Mr. J. Makaruk, 17, Overleigh Drive, Buckley	
Site Plan	
Dwg No. M16/3	Rev. B
Scale 1/200 @ A4	Date Feb 2015
Tel:07792 595 480

Please accept this email as my personal statement for the committee review regarding application 061817;

Revisions to the original planning application 053265 for the above property were made in December 2019 under drawing number M16/2 Revision A. These are extensive alterations! Under what previous application number were the revision A proposals approved?

Proposed Plan

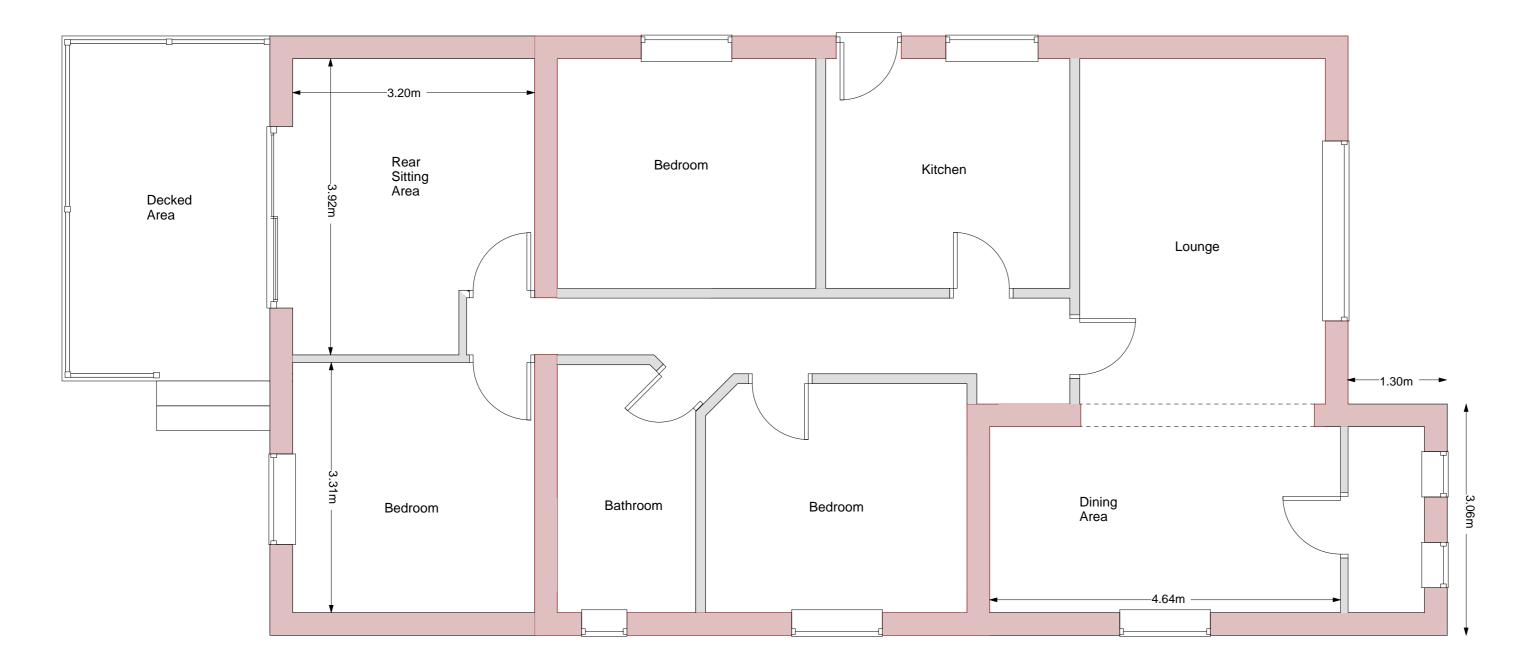
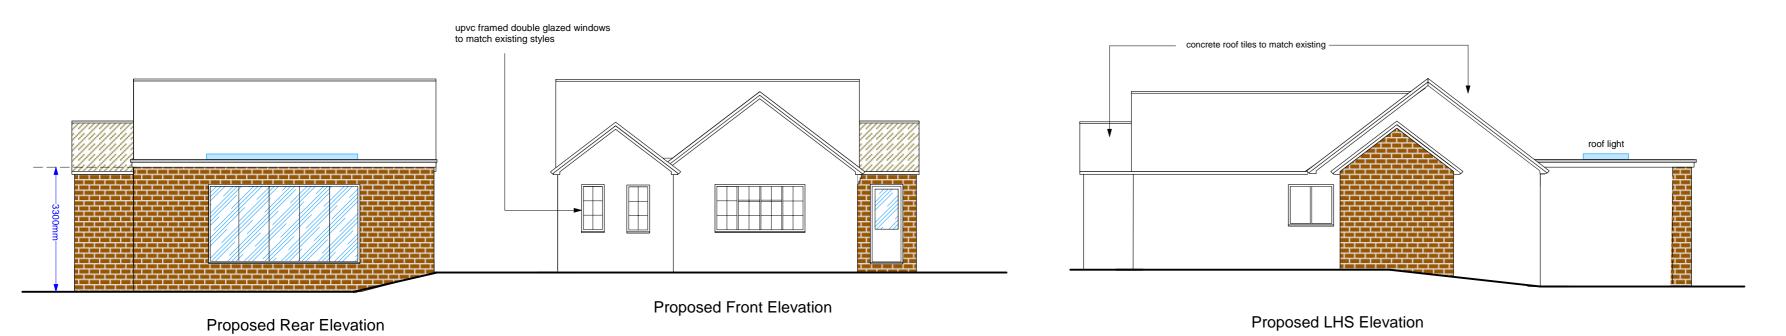
However, a window was introduced into a bedroom on plan M16/2 under application 053265 which faces an existing window at number 16 Overleigh Drive which does cause an adverse impact. This did not form part of the planning appraisal and the adverse impact was not considered. This requires a review under the current application to remove the adverse impact on number 16. (Plan M16/1 part of application 053265 shows the pre application property with NO window in the bedroom facing number 16)

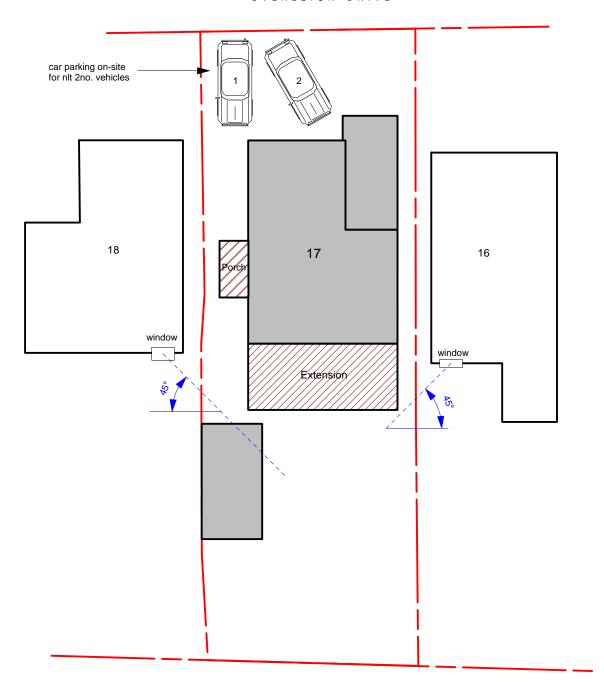
Current application 061817 shows plan M16/3 revsion B with 45 degree markers shown in releation to the extension. Are the markers shown in relation to the extension 3.2meters from the original property or the revised 4.0 metres from the original property? Plan M16/3 requires the extension dimension adding relative to the 45 degree markers.
